**EL PASO WATER UTILITIES  
PUBLIC SERVICE BOARD**

**ADDENDUM 2  
FOR**

**HASKELL R. STREET WASTEWATER TREATMENT PLANT FATS, OIL AND  
GREASE RECEIVING STATION IMPROVEMENTS**

**BID NUMBER 93-22**

E-02

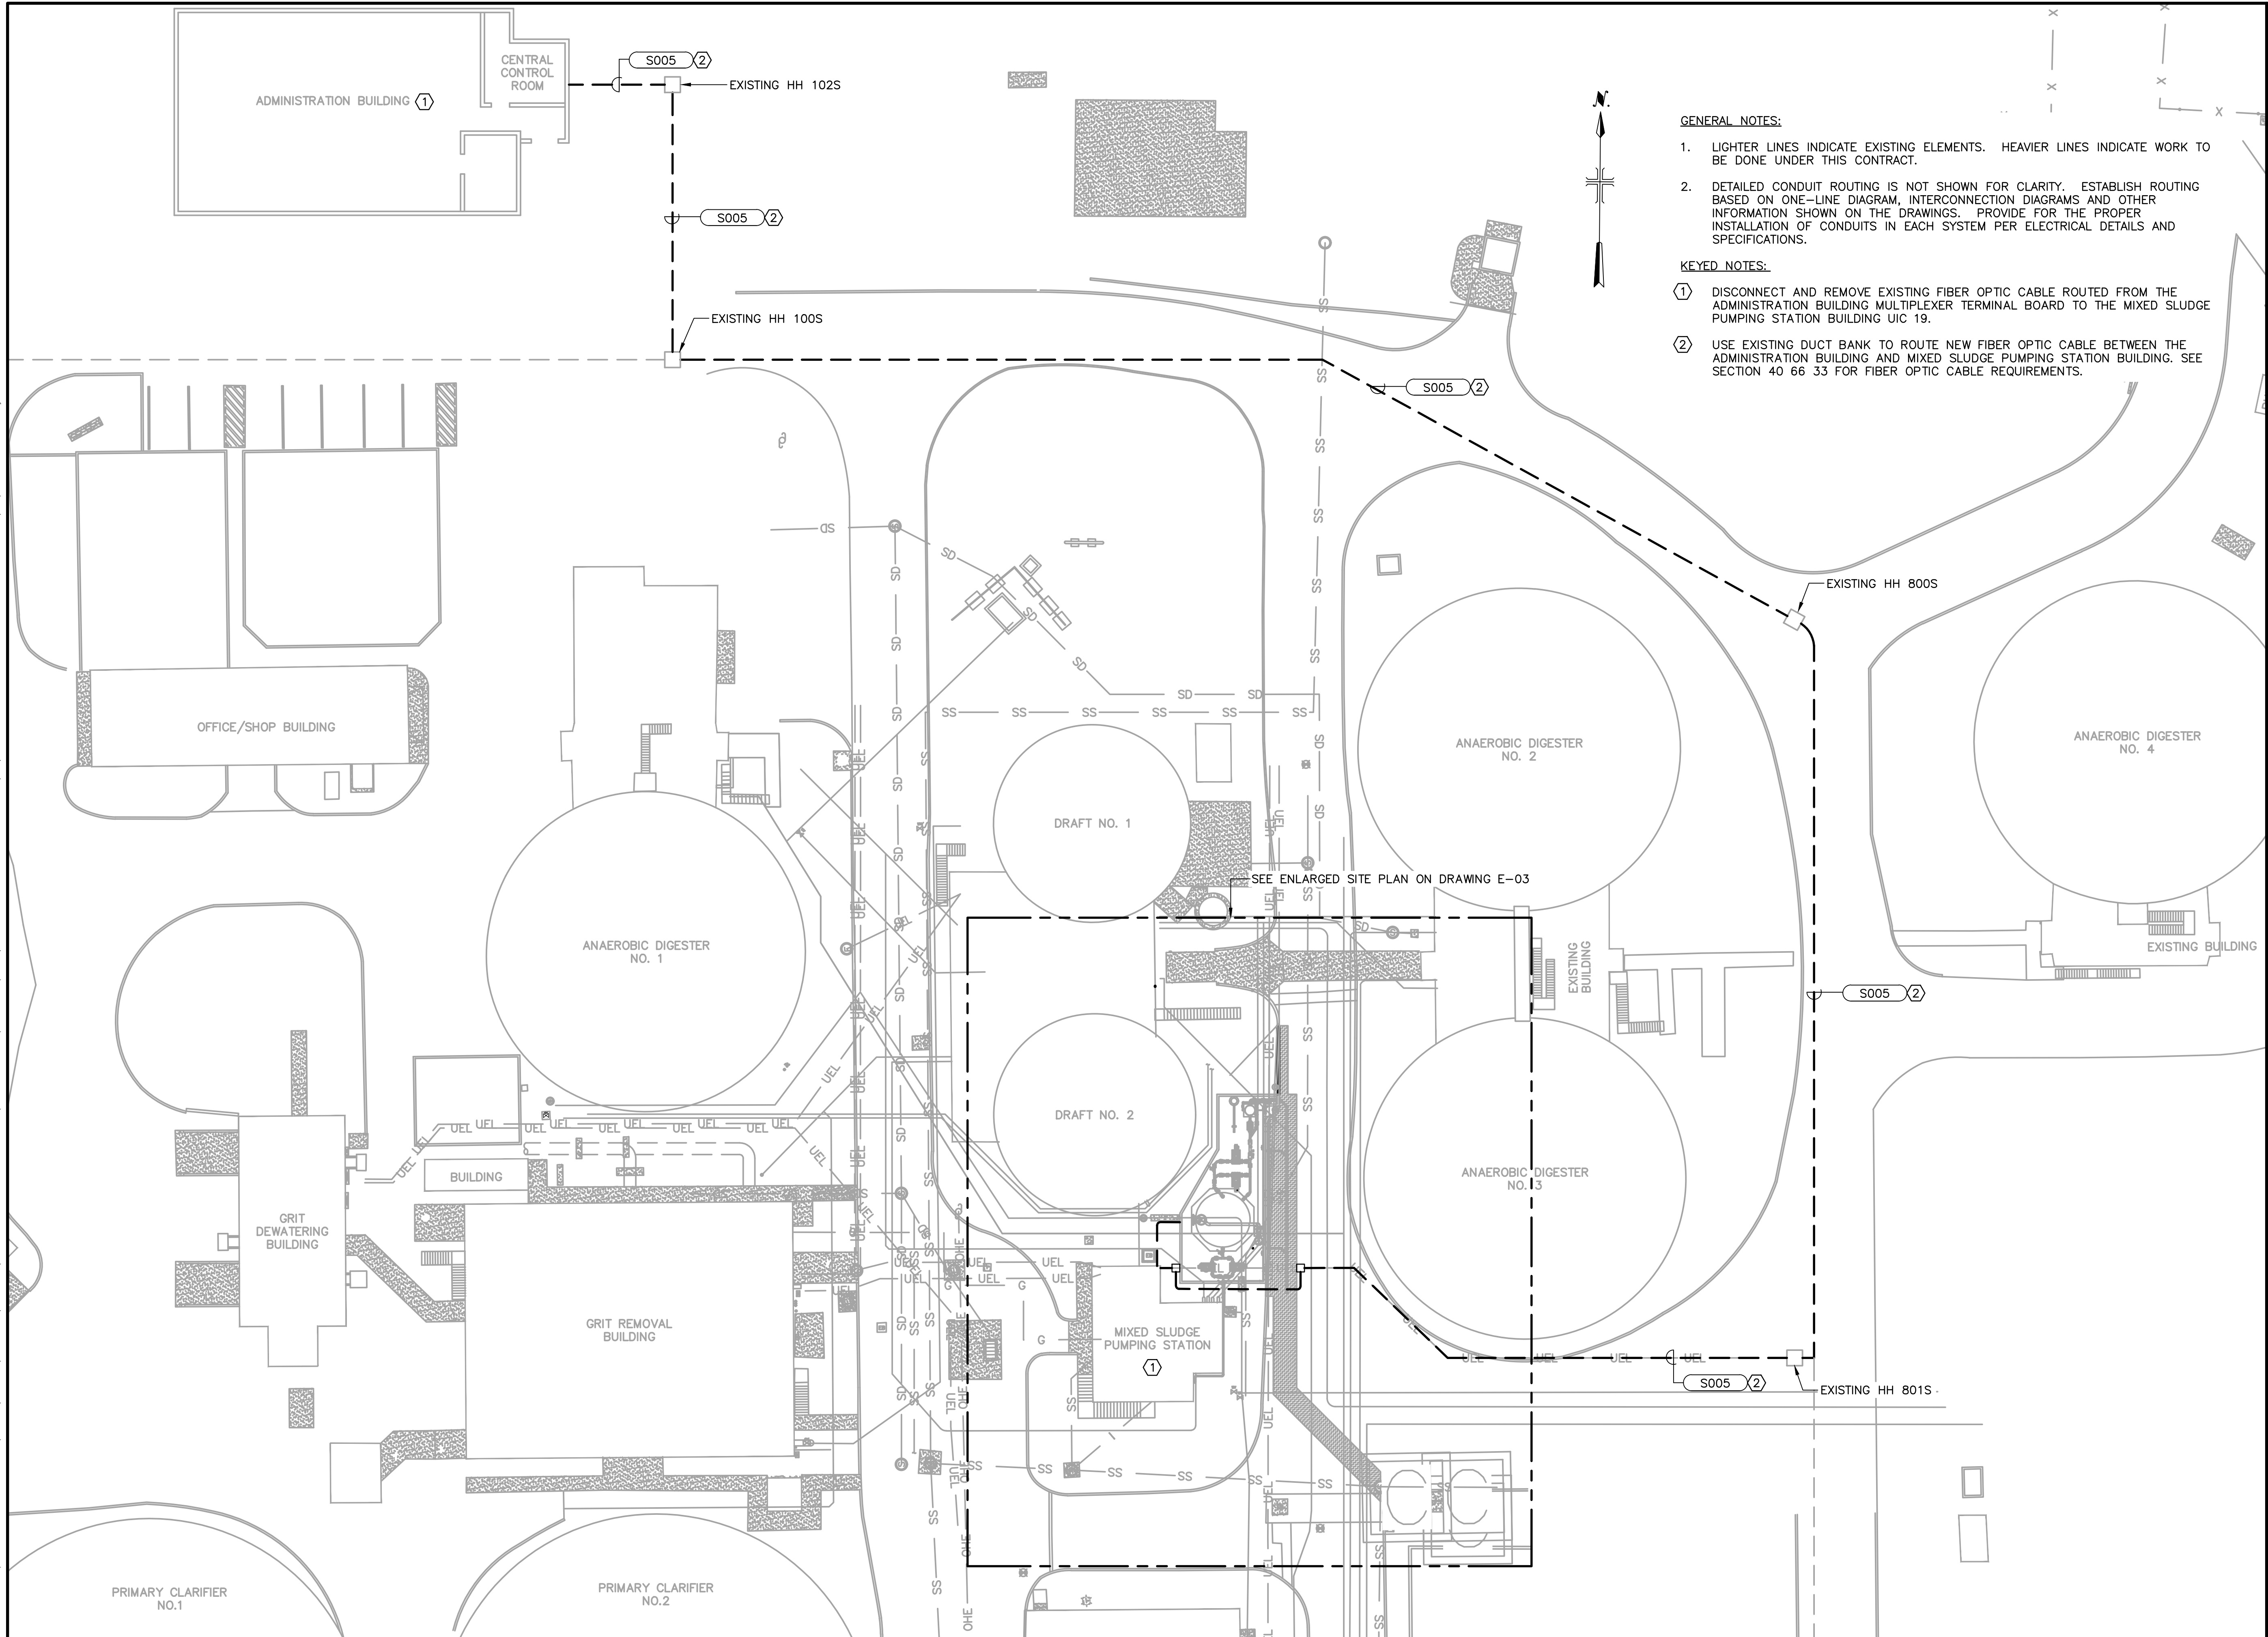
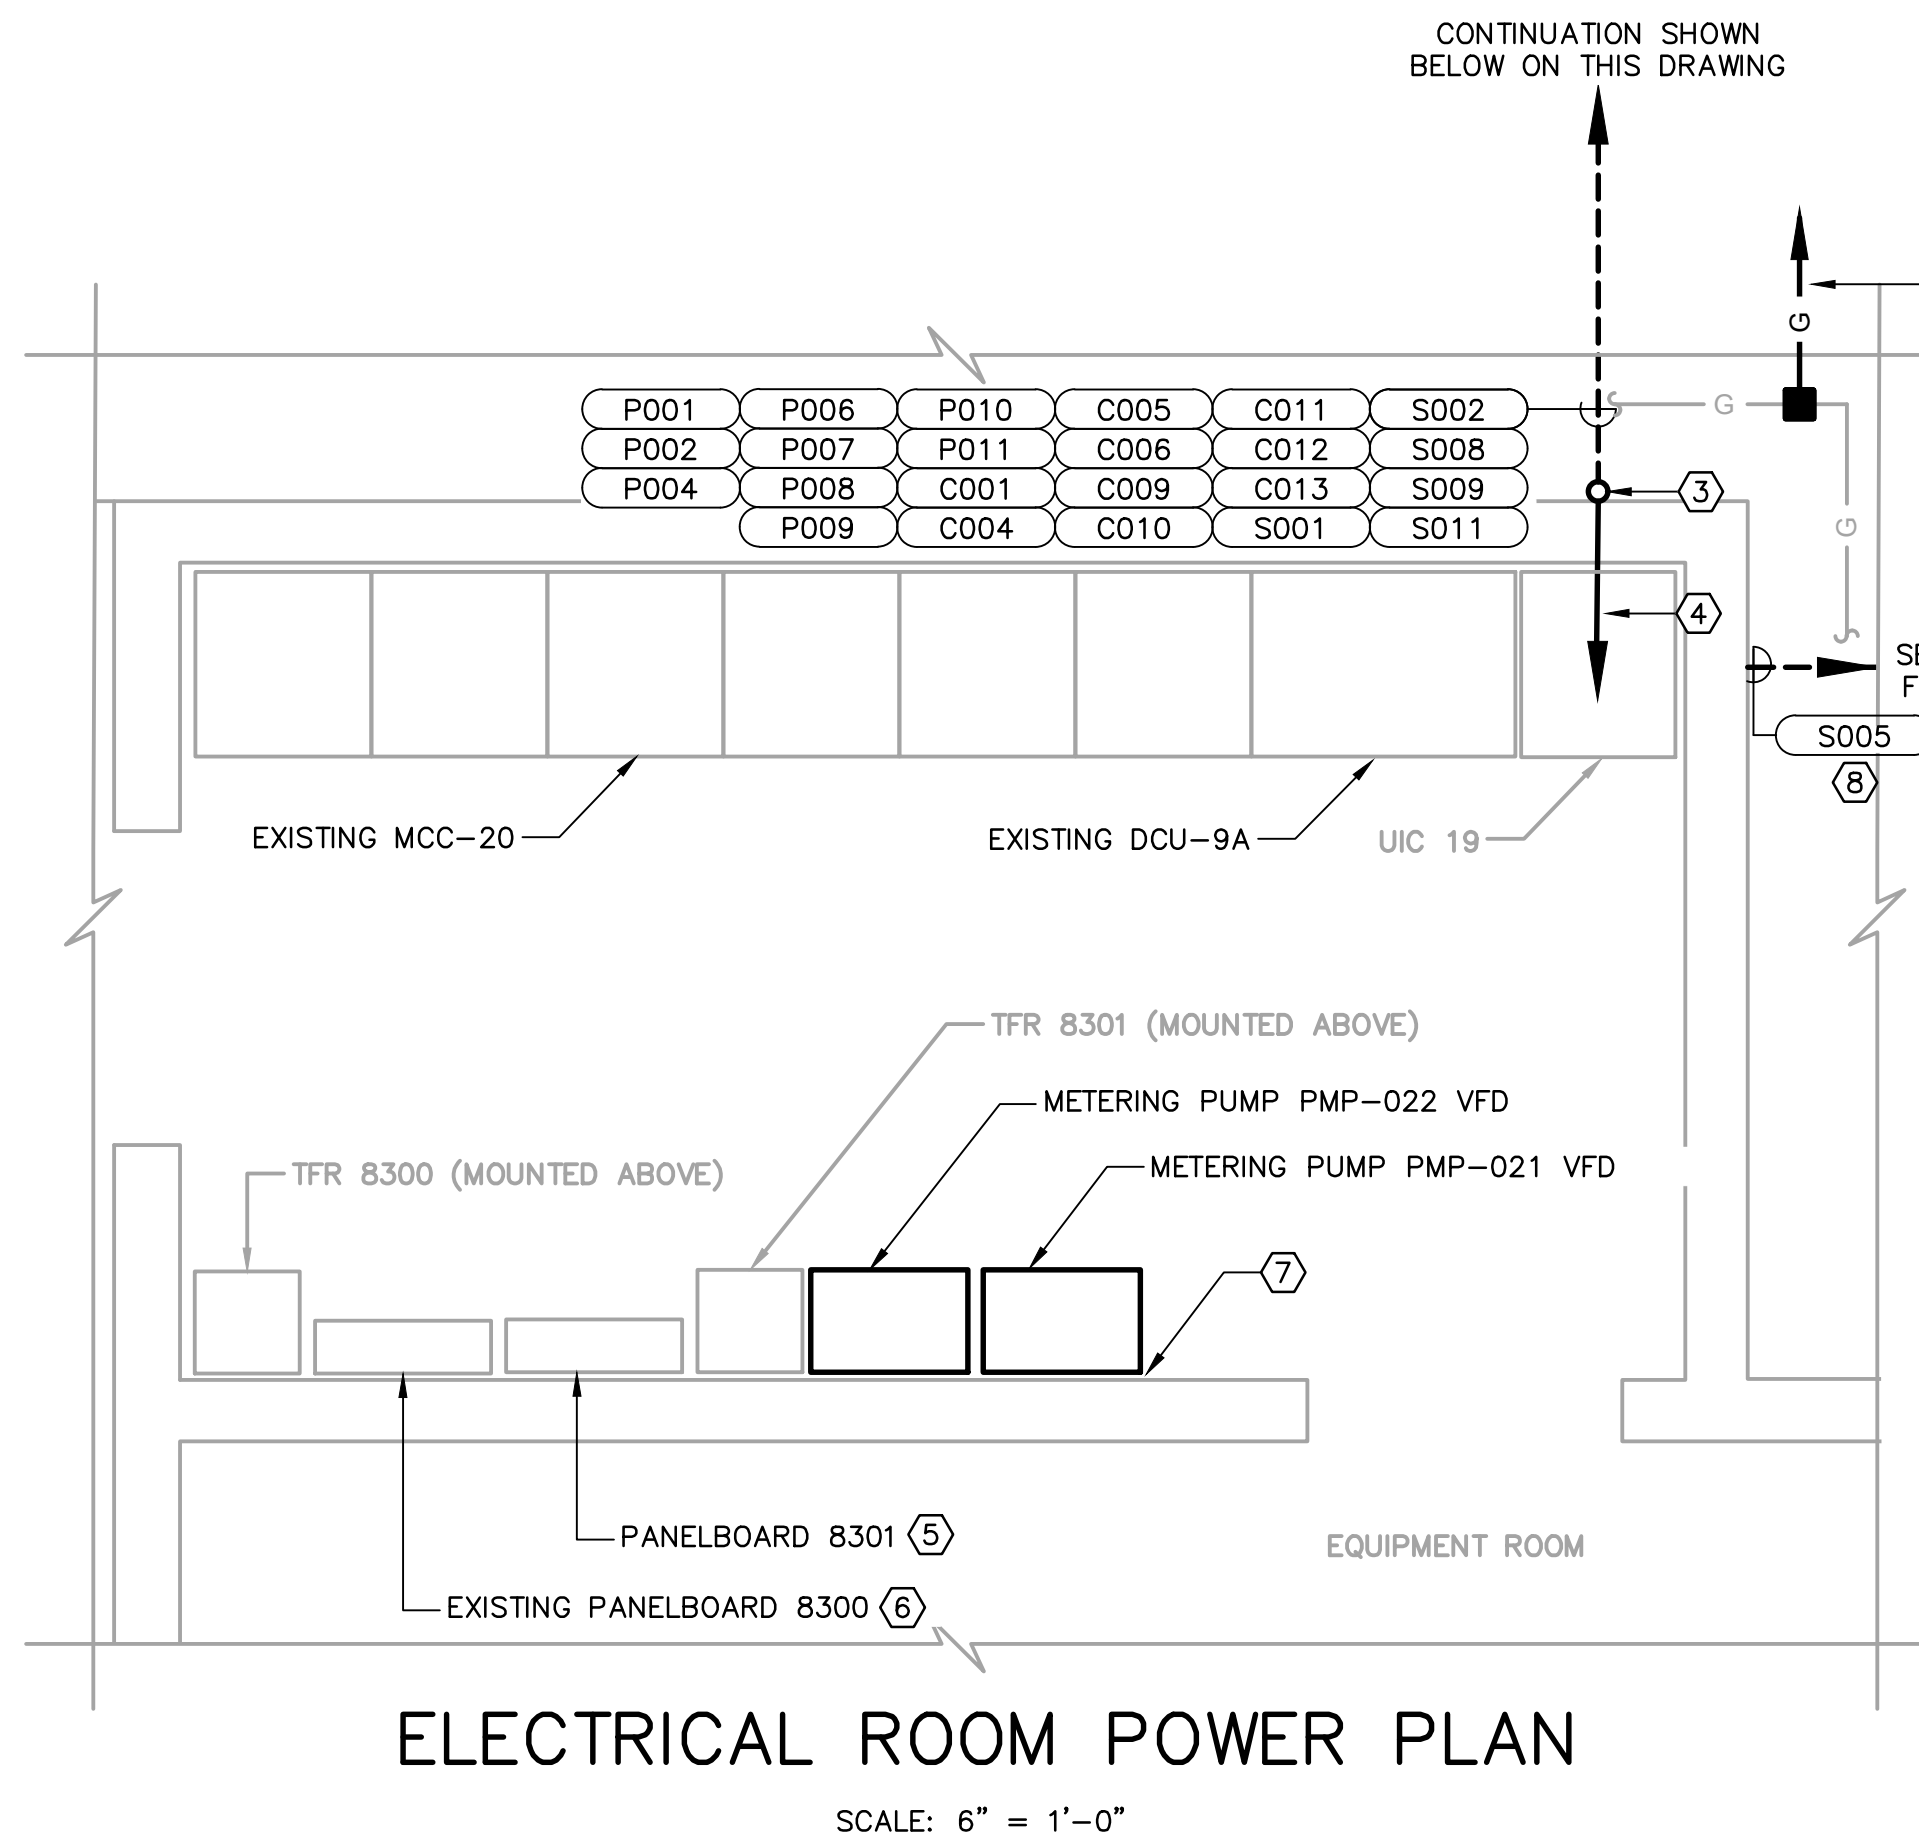
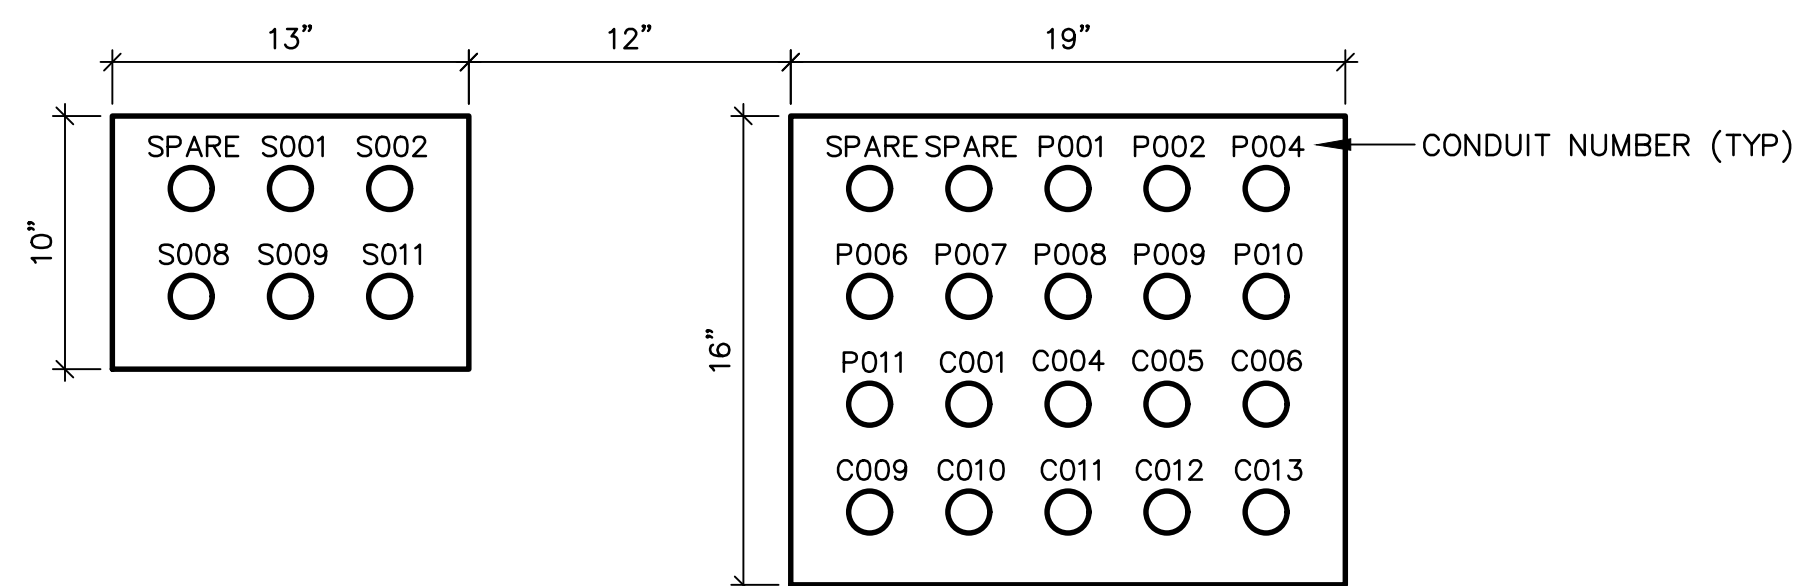
**QUESTION 8:** It appears the scale is off on sheets 27, 28 and 30 please check?

**ANSWER 8:** Sheets E-02, E-03 and E-05 have been revised to correct the scale. Revised sheets are attached.
